380 Tunxis Road Subdivision

**Subject: 380 Tunxis Road – Orchard Heights Developers, LLC
Subdivision Application #298 and IWW Regulated Activity #1097**

RE: Orchard Heights, 380 Tunxis Road

Sheet 12

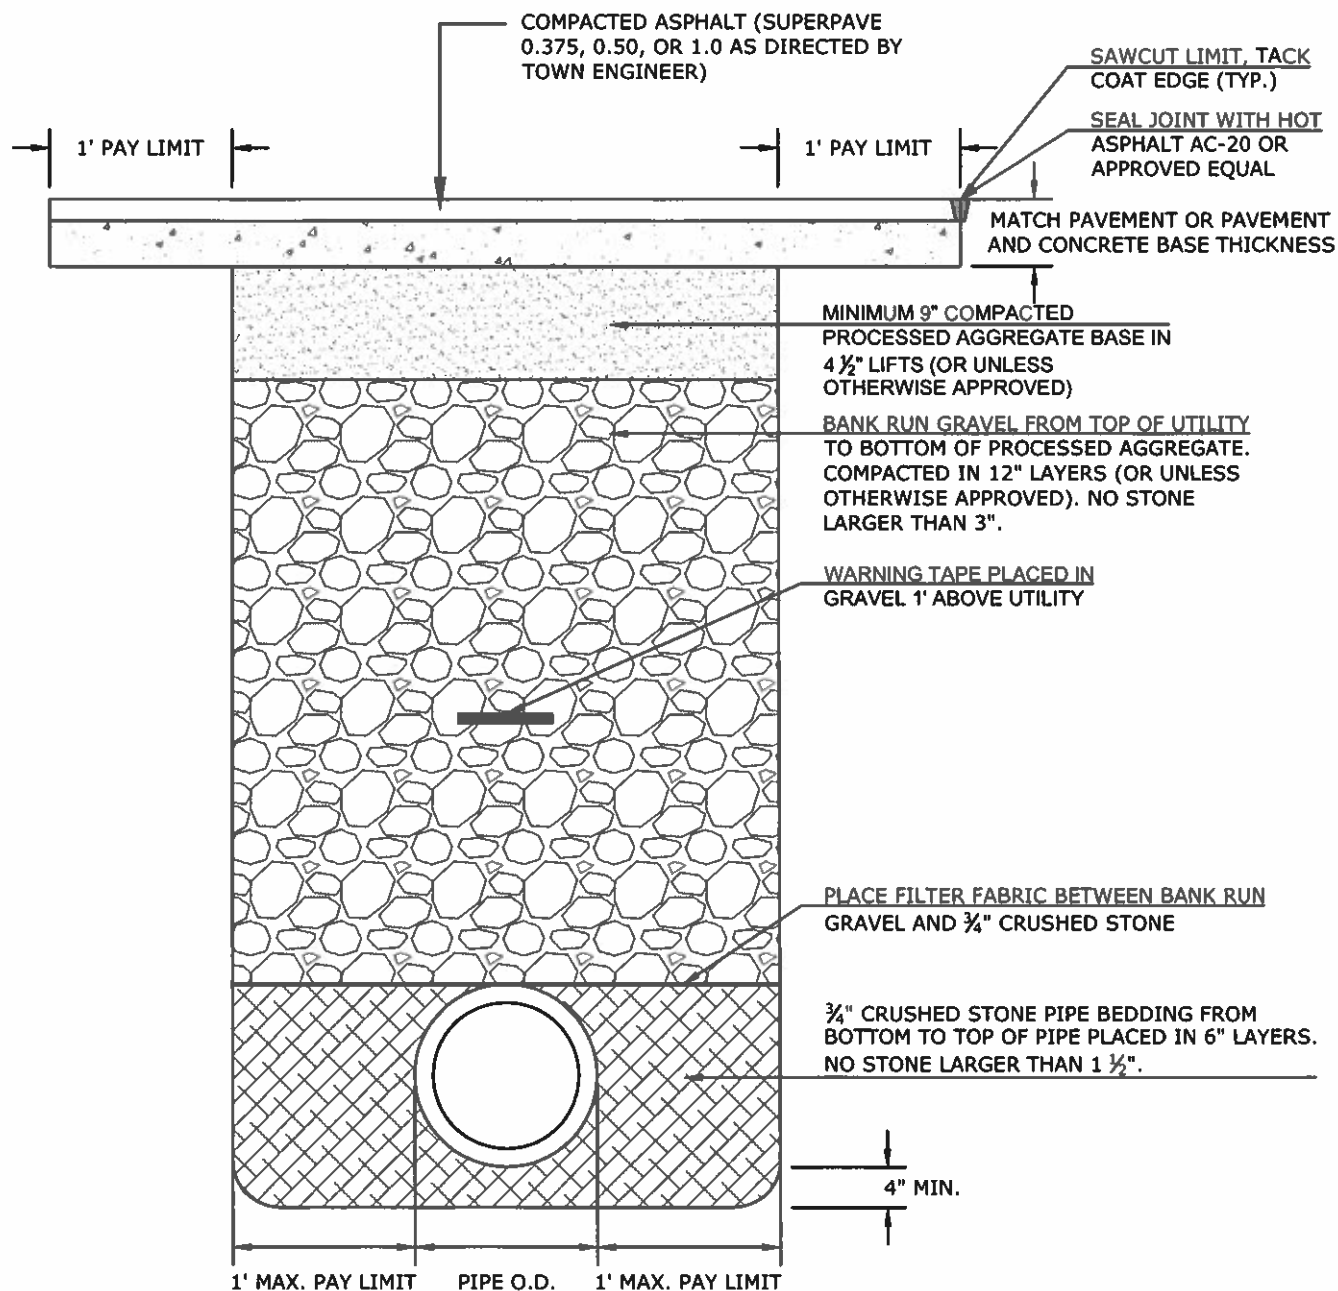
49. Please verify, the fourth paragraph, first column mentions phased erosion and sediment control plans.
50. In the ninth paragraph first column, "...this time..." please change to construction.
51. In the second column, the first four paragraphs state "...as required above..." or "...as noted above...". Unclear what the reference is to, please revise.
52. In the second column, eighth paragraph it states "...installed as shown on plans...". Please verify.
53. Verify the sequence of construction, it mentions parking and doesn't mention planting of trees or island planting.

TOWN OF WEST HARTFORD
DIVISION OF ENGINEERING
 INFRASTRUCTURE RULES & SPECIFICATIONS
 NOT TO SCALE | REV: 1/2018 | EXHIBIT: #
 STREET EXCAVATION TRENCH
 RESTORATION DETAIL - DRAINAGE

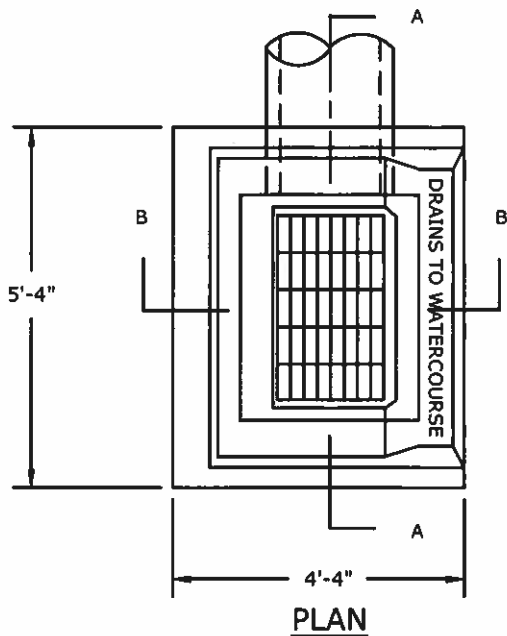
37. Show detail for 4" perforated edge drain.
38. The Town's Street Excavation Trench is being provided for drainage within the roadway.
39. The leader overwrites the text on a couple of details.

TOWN OF WEST HARTFORD
DIVISION OF ENGINEERING
 INFRASTRUCTURE RULES & SPECIFICATIONS
 NOT TO SCALE | REV: 1/2018 | EXHIBIT: #
 TYPE 'C' PRECAST CATCH BASIN

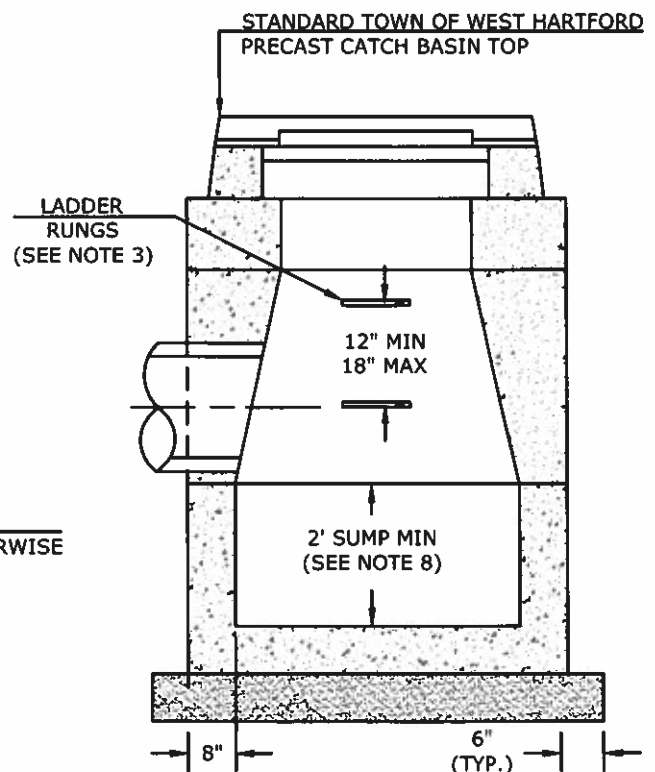
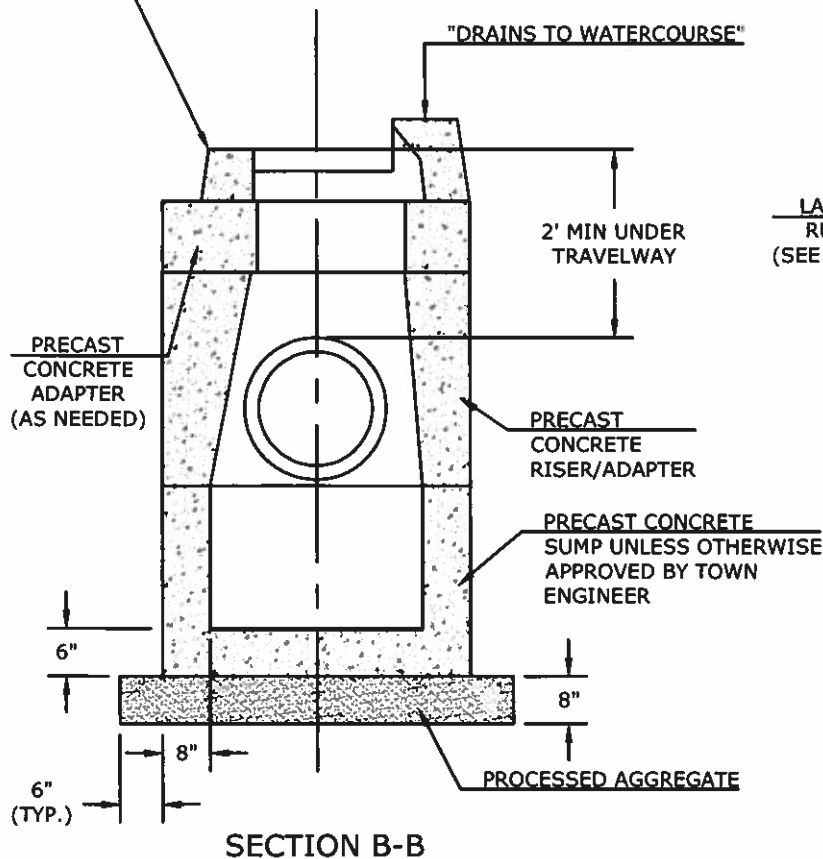
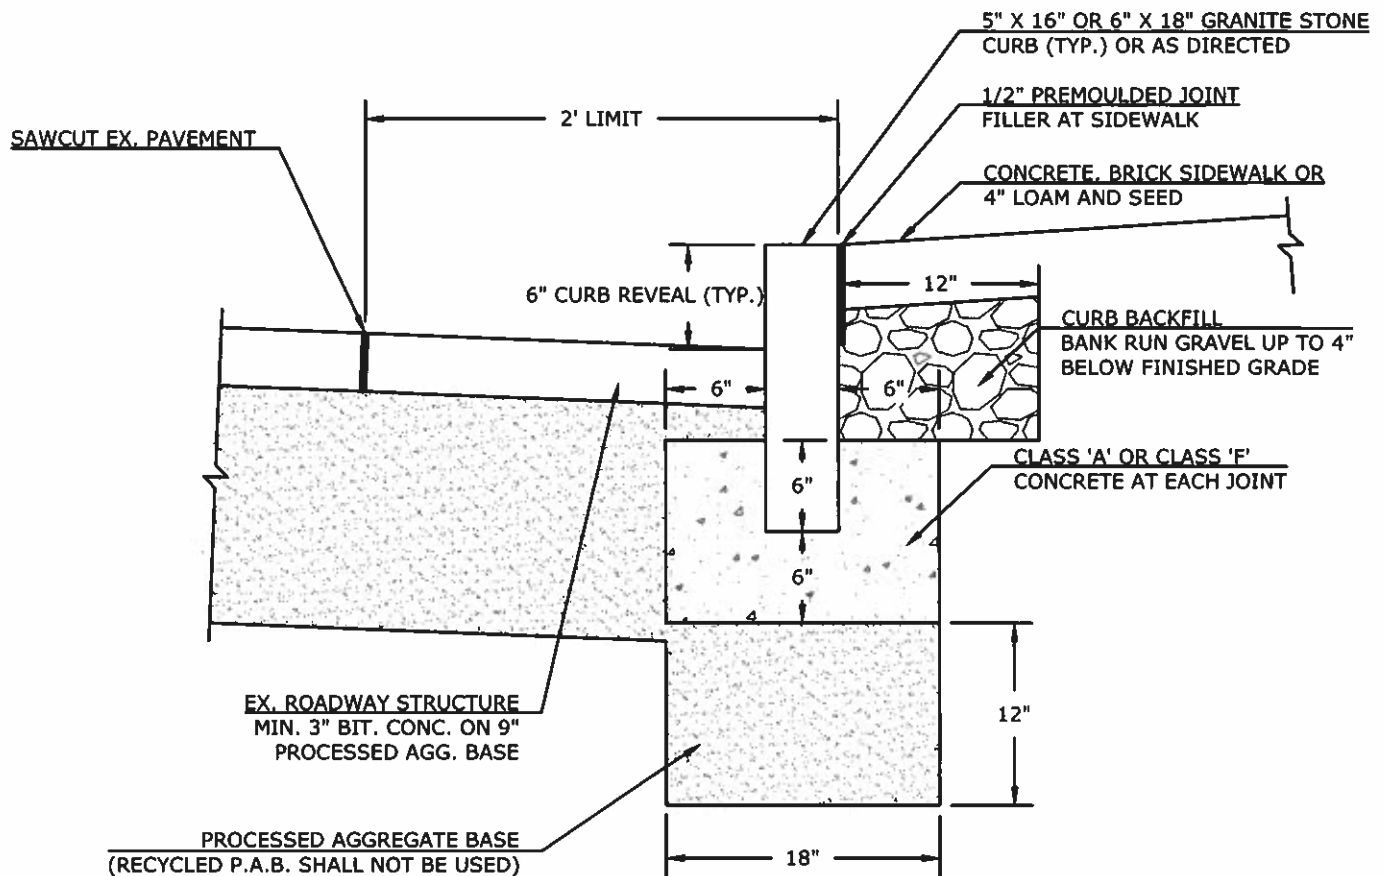
40. The Towns Type 'C' catch basin top states "Drains to Watercourse". See attached.

STRAIGHT GRANITE CURB DETAIL

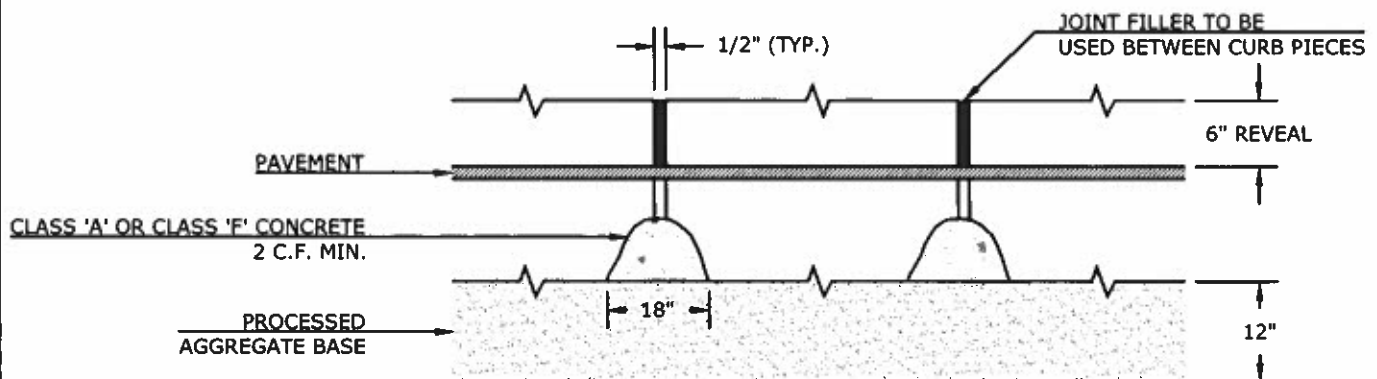
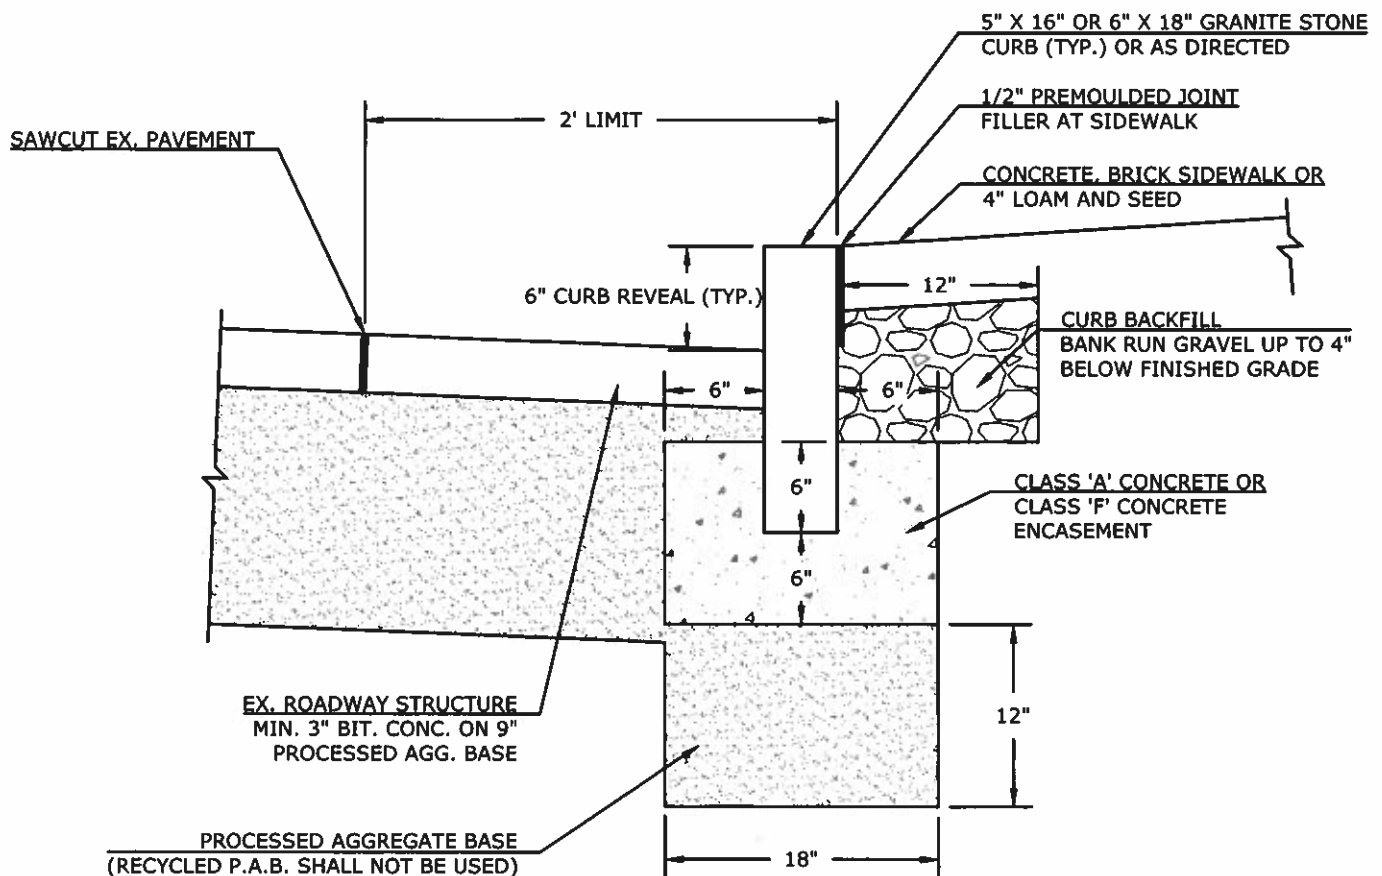
41. Sanitary sewer design, details and specifications shall be in accordance with the Metropolitan District (MDC).
42. Show details for granite curbing: straight and curved. See attached.
43. Show details for retaining walls.
44. Show details for guide rail.
45. The bituminous concrete lip curbing detail does not match the sequence of construction. Please revise.
46. Please revise the Public Road Cross Section Detail: 26' wide pavement, 50' right-of-way, and 1.5" HMA S0.375 surface course on 1.5" HMA S0.5 binder course on 9" compacted processed aggregate base.
47. Include merestone detail. See Attached.
48. Show detail for Water Quality Structure.
